SUBDIVISION REVIEW SHEET

CASE NO.: C8-2021-0152

SUBDIVISION NAME: Pinnacle at Wildhorse Ranch Preliminary Plan

**CITY OF AUSTIN –DEVELOPMENT SERVICES DEPARTMENT
SUBDIVISION APPLICATION – MASTER COMMENT REPORT**

PRELIMINARY PLAN
FOR
**PINNACLE AT
WILDHORSE
RANCH**
CITY OF AUSTIN,
TRAVIS COUNTY, TEXAS

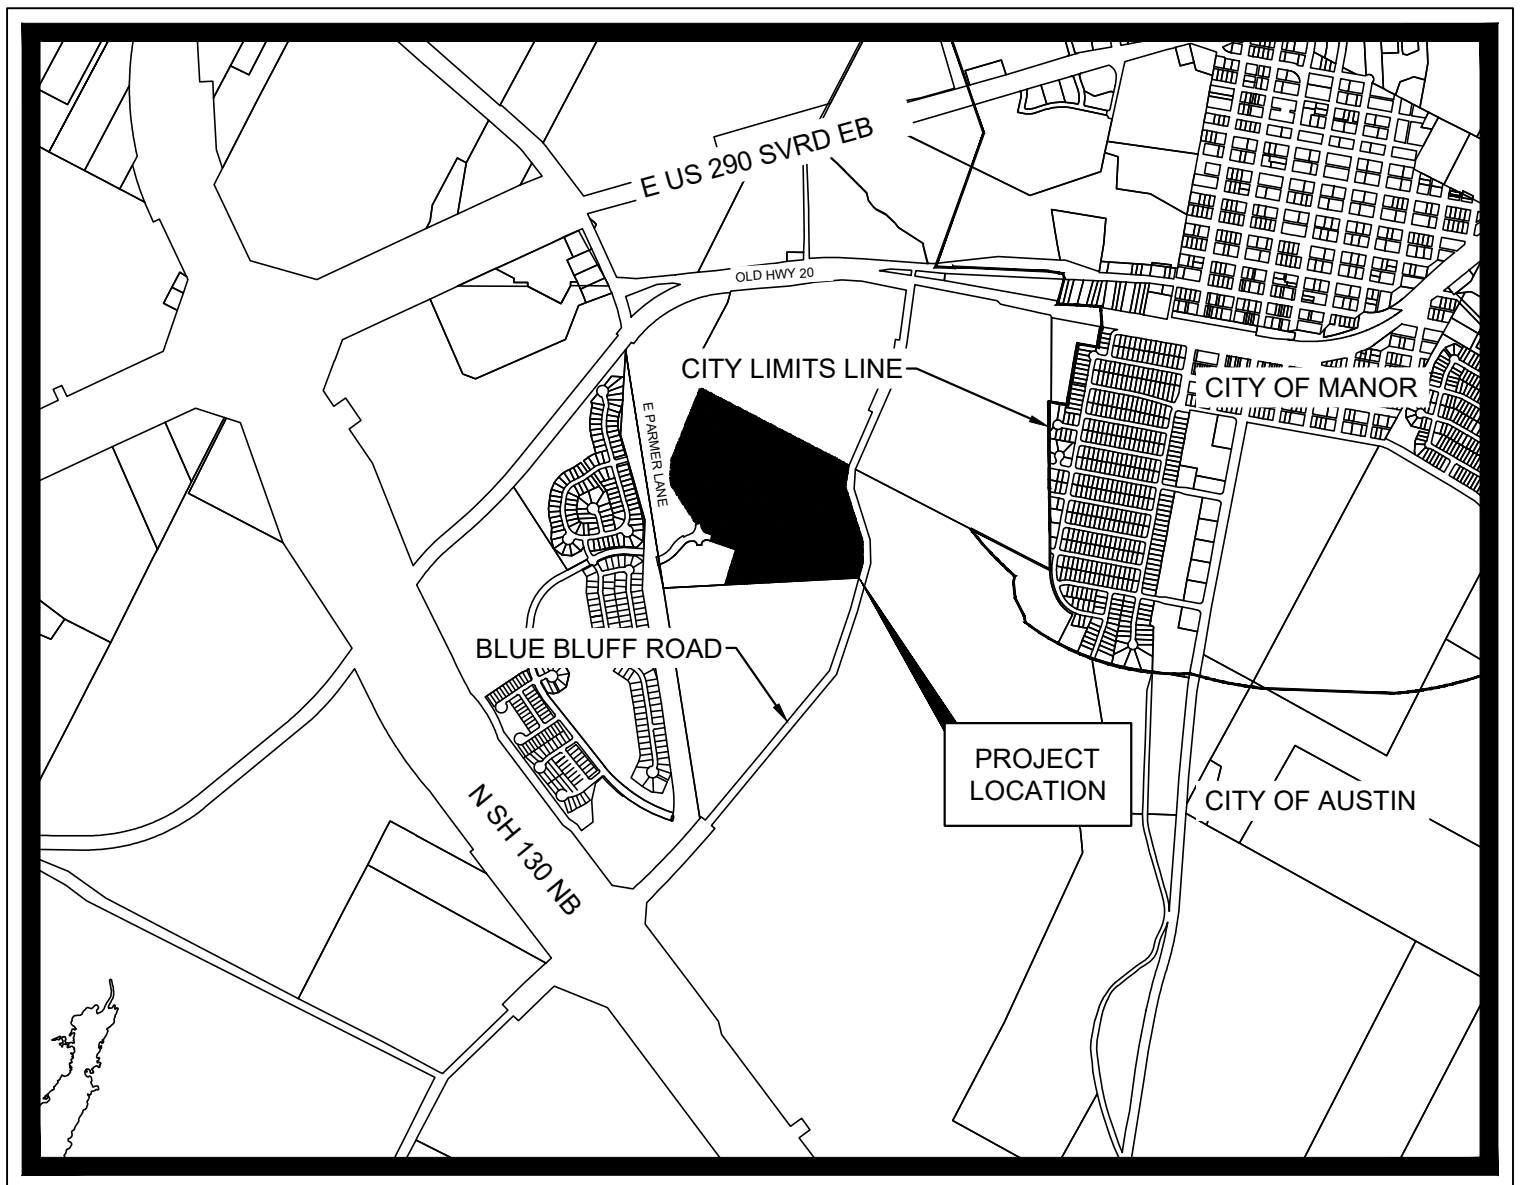
AD2: Remove (Proposed) that is labeled below the street name GOLDEN RODEO COVE. There is no existing GOLDEN RODEO COVE, therefore it is not needed on your plan.

- ATD 6. Add subdivision construction case number (C8-2017-0291.1B) to the WILDHORSE RANCH TRAIL (West of the roundabout).
U1: Comment remains. Please, change the location of the case number to the west of the roundabout. Previous comment had a typo.

Per TCAD, this property appears to be owned by Texas WH200 LP with the most recent deed recorded in Document No. 2010177691. Please update the preliminary plan application with the ownership information and have the correct owner sign the application. Also, the owner's information should be updated on Sheet 1 of the prelim. (LDC § 25-1-83)

- **Update 1: ROW boundaries and internal lot lines of the proposed subdivision should appear less bold than the prelim boundary. For example, the ROW lines for the Wildhorse Trail extension and the interior lot line boundaries for the larger lots should match the line weights for the smaller lots. Only the very outside boundary should be bold.**

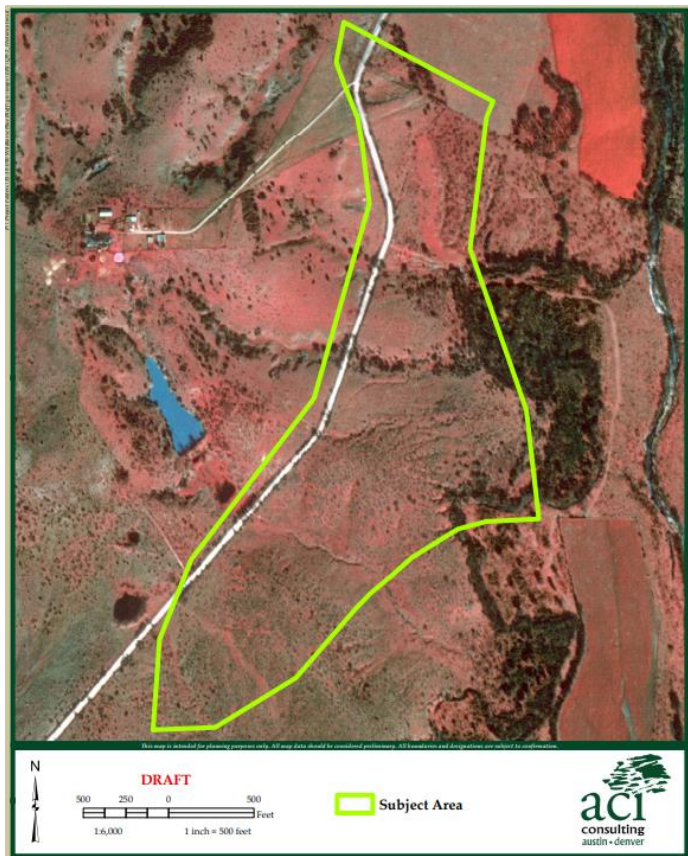
WB1 Please provide a compliant ERI for the project location associated with this plan. The ERI provided with the plans is for an adjacent property.

Update 1 The ERI provided with the application covers the area indicated below (image from the submitted ERI). The project location associated with this case number is on the west side of Blue Bluff road and west of the area covered by the submitted ERI.
